EQUIPMENT UPDATE

Effective Date: 11-15-05
Log Number: EU-11-370

Part: PERI-PUMP FACE PLATE

PERI-PUMP FACE PLATE

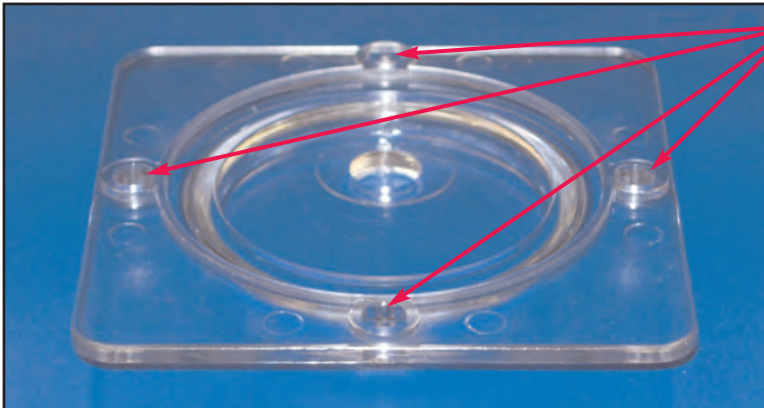
Peri-pump Face Plate (PN 418.00) tooling has been modified to include stand-offs around mounting screw holes that secure face plates. We believe this will prevent face plates from cracking. Face plates will be available as of November 15, 2005 (part number remains the same).
